# East Cambridgeshire District Council

## Meeting: Planning Committee

Date: Wednesday 3 June 2024

## LEVEL MONITORING

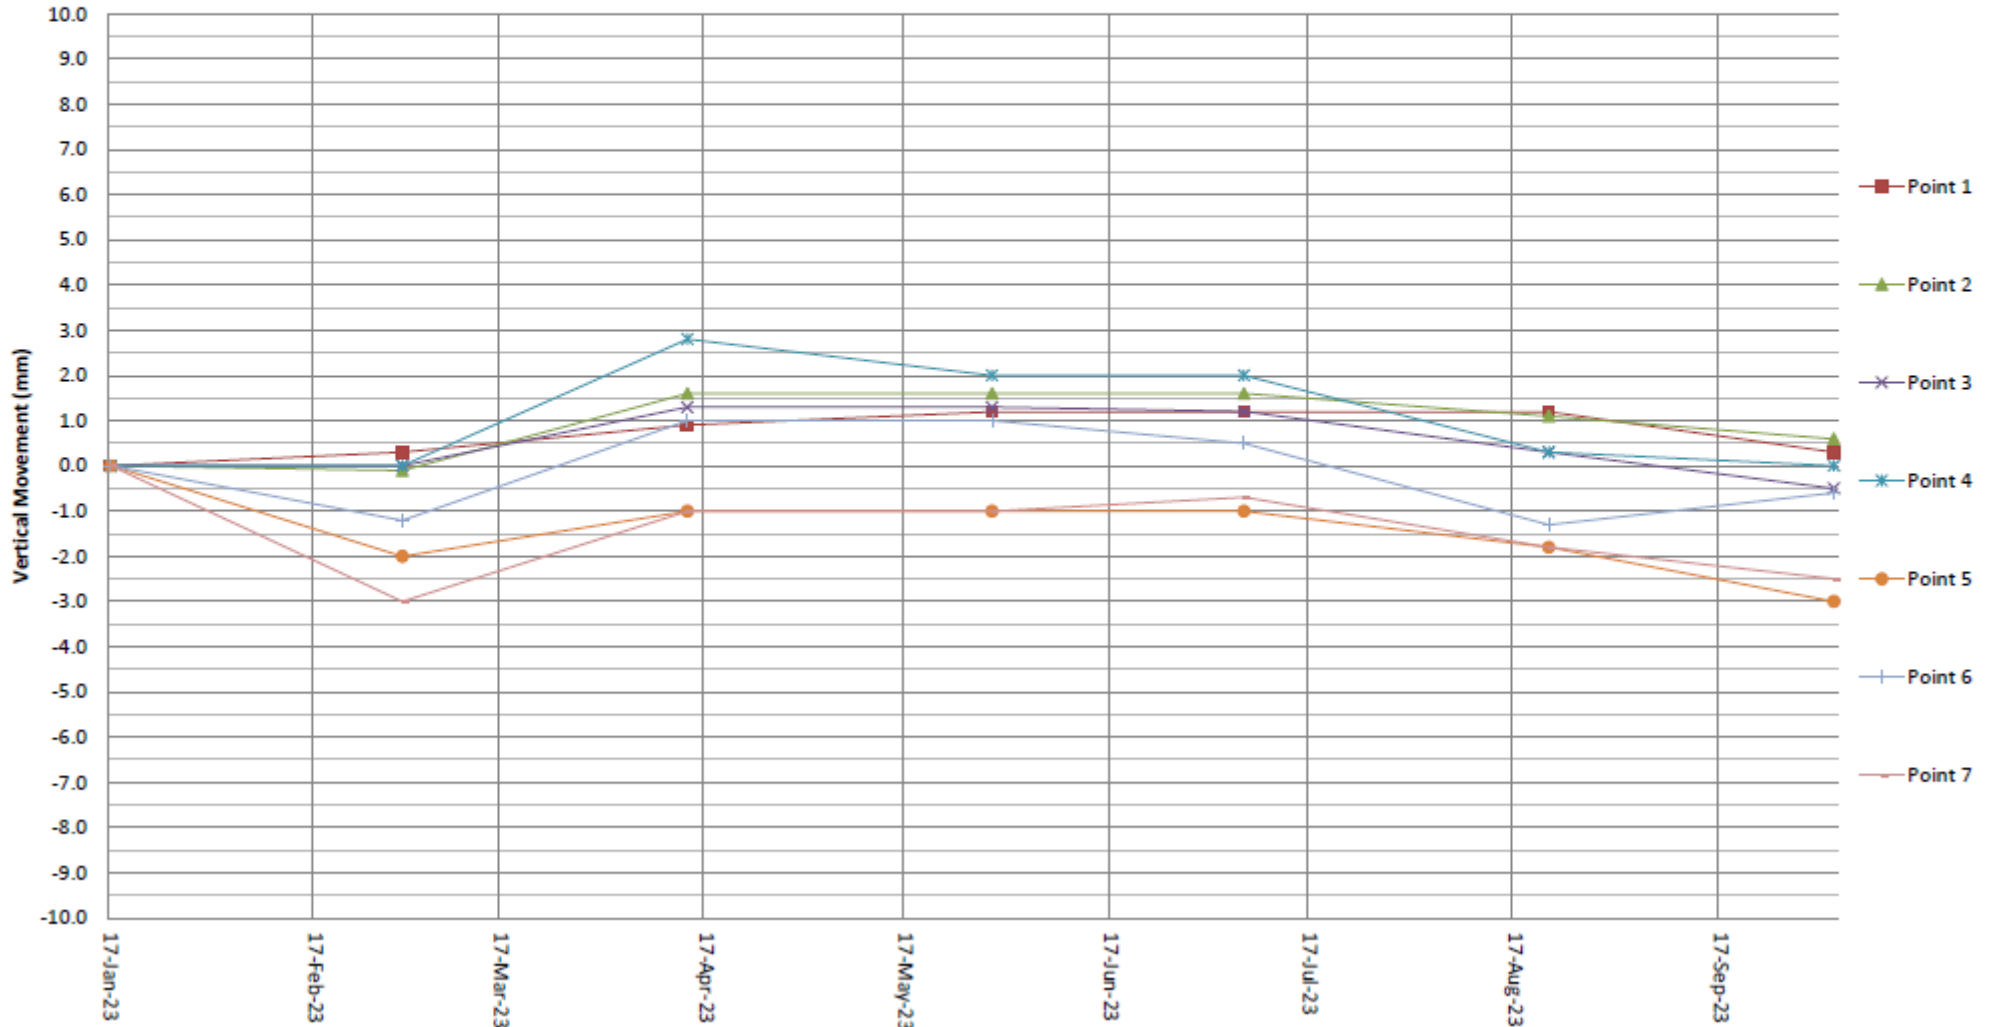
In regards to the level monitoring information most of the readings show an increase in levels apart from points 5 and 6 where point 5 dips below the datum point in July which could be tree related and a larger dip in October which is unlikely to be tree related and point 6 only dips below the datum once in November which is highly unlikely to be tree related. The cracking on the buildings front which relates to points 5 and 6 doesn't match the typical tree related diagonal cracking. The report mentions that the lack of soil level movement up or down between April and July indicates tree related seasonal influence as this is the time of year when rainfall is limited and tree growth is at its most active a tree's influence would cause the soil to shrink, whereas the main time when soil shrinkage is shown on the level monitoring information is in October to November when trees are entering their dormant period which should indicate that there is another cause for the properties movement other than the low water demanding Silver Birch tree.

In the level monitoring information, most of the readings show a decrease in level between 17 February and 17 March apart from points 1, 2 and 4 which stay the same or increase, point 4 is one of the closest to the tree. There is then increase in levels between April and June. The levels begin to dip again from July to the last reading after September. The points with the largest movements are points 5 and 7, point five is closest to the tree on the corner of the property adjacent to Broad Street and point 7 is on the furthest corner adjacent to Broad Street where the property joins its neighbour. Points 1, 2 and 4 show an increase during the summer months above their starting level finishing the monitoring period at the same level or higher than they started it.

Figure 3.3 – Site Access – Proposed T-Junction

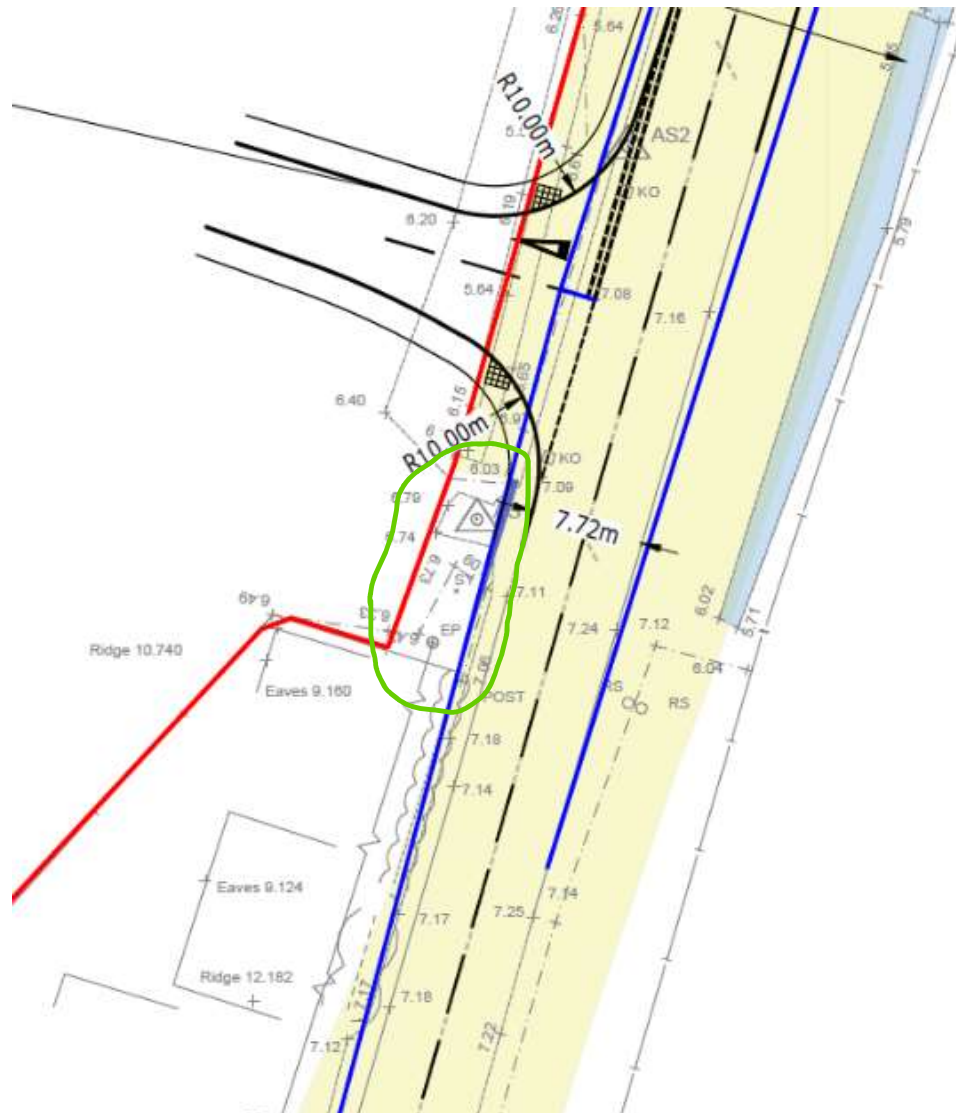
- 3.2.7 Stantec questions whether the 120m visibility splay can be achieved to the right of the proposed site access. The splay is obstructed by further existing vegetation intruding into the highway - as shown in **Figure 3.2** - as well as third-party land. The photo in Figure 3.2 has also been taken 2.4m back from the main carriageway kerblin to mimic the position of a driver waiting to turn.

3.2.8 Whilst Stantec accepts vegetation within the highway may be removed to increase visibility, the site access drawing (2006310-004 Rev B – Proposed Site Access Arrangements – Priority 'T' Junction) does not provide sufficient detail to confirm that the right visibility splay can be provided without potentially needing third-party land, as well as the construction of the footway kerb line (adopted public highway been shown as shaded yellow). The area of land in question is circled green below in **Figure 3.3**, and does not appear to be within public highway or the development red line boundary.

3.2.9 Stantec recommends the Applicant is required to provide further detail of the highway boundary for review to determine whether an appropriate visibility can be achieved without third party land.

Figure 3.4 – Google Maps Typical Traffic Conditions

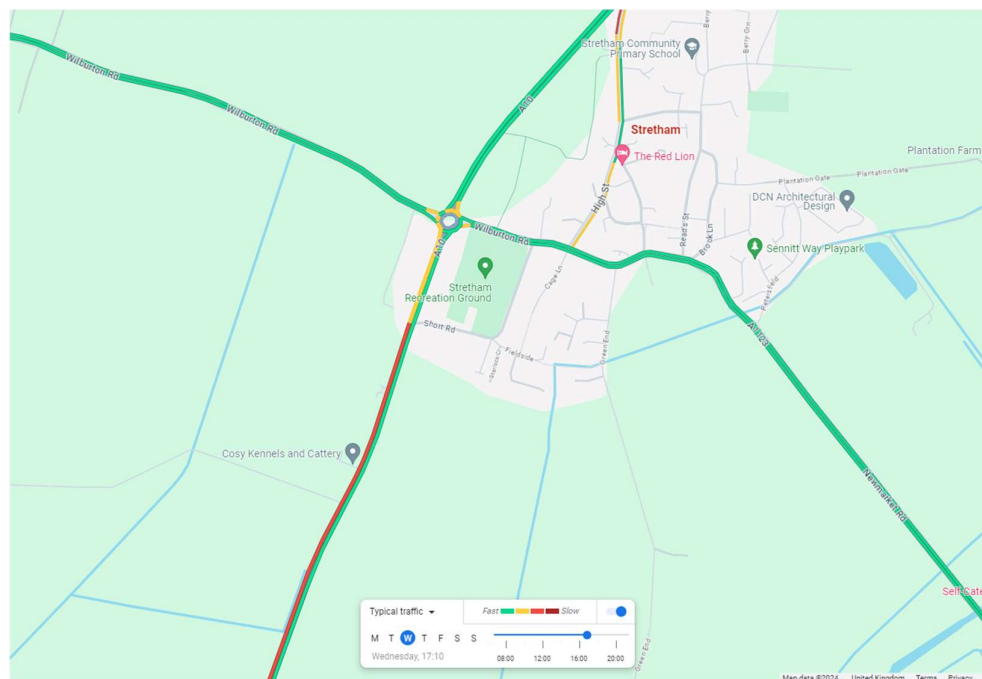
- 3.3.10 The CCC Highways Officer response referred to the A10 / A1123 roundabout peak period congestion leading to queueing traffic on the A10 extending to the proposed site access which could prevent vehicles from exiting / entering the site.
- 3.3.11 The Google Maps typical PM Peak traffic conditions shown in Figure 3.4 shows this.

3.3.12 As conditions at the A10 / A1123 Roundabout were not assessed as part of this Transport Assessment, Stantec is unable to comment further.
